A REPAIR

SEWAGE DISPOSAL SYSTEM

HOWARD COUNTY

SUBDIVISION Greenwood Farms ROAD 7519 Greenwood Dr. LOT Parcel 157 Lot 50

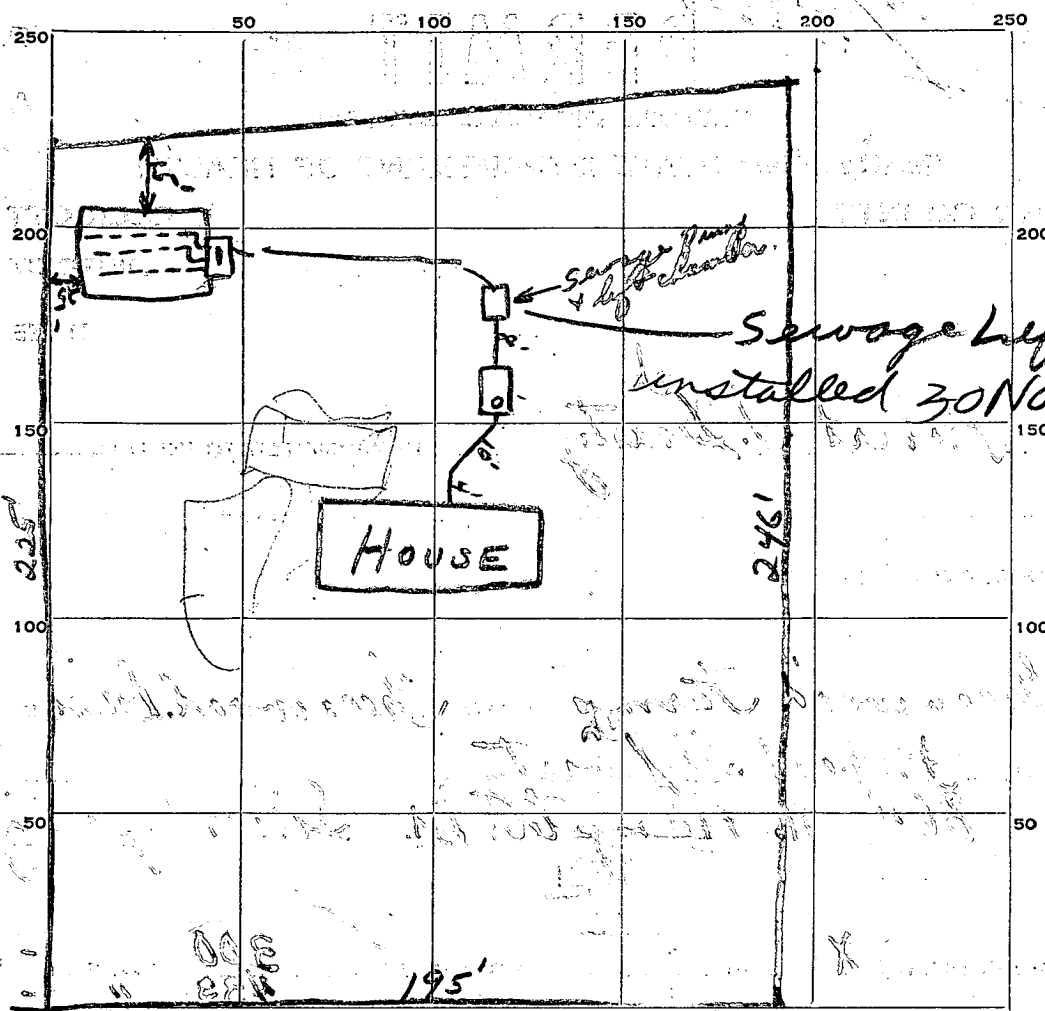
OTHER Drain field to be installed in the area Reason for retest: Ground water at 5 ft in area tested for tile field - discovered after house built.

8-30-62 Retested: Leaching bed 15 ft wide by 25 ft long located 25 ft off left side property line and 15 ft off the rear property line. Depth of bed 4 ft from original ground at shallow side of bed which is side closest to rear wall of house. Locations determined from lot from Greenwood Drive. Note: Install sewage lift pump & separate 300 gal. chamber for discharging effluent to leaching bed J.H.

REMARKS 11-8-62 Perforated pipe changed in bed. Sewage lift pump not yet installed nor sewer line pipe taken to bed. R/H
30 NOV 62 Sewage Lift Pump installed R/H

LOT 50 Block 18
 PARCEL P. 157
 7519 GREENWOOD DR.

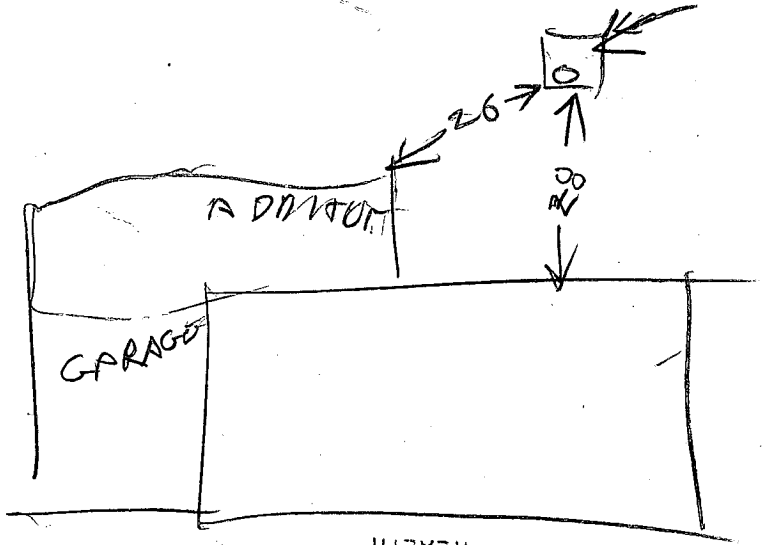
Pump Chamber for sewage left pump

appears to be well 6 FT from corner of House RH corner

PROPOSED 3 CAR GARAGE 24'x38'

DO NOT SIGN

SEPTIC TANK APPEARS TO BE UNDER ADDITIONAL NO ONE HOME MUST CONTACT HOMEOWNER See other red

*OFF Blount Bridge Rd.
 4/2/86*

*OK TO SIGN NOW
 REVISITED STB
 RH*

4/1/86 Mr Eye returned call He is going
to take off addition Septic tank
Pump Pit & Bed

SEPTANK & PUMP PIT
FROM REPAIR
OF 1982

4/2/86 - NO PROBLEM FOUND TANK
SITE & ADDITION & TALKED TO
MR EYE
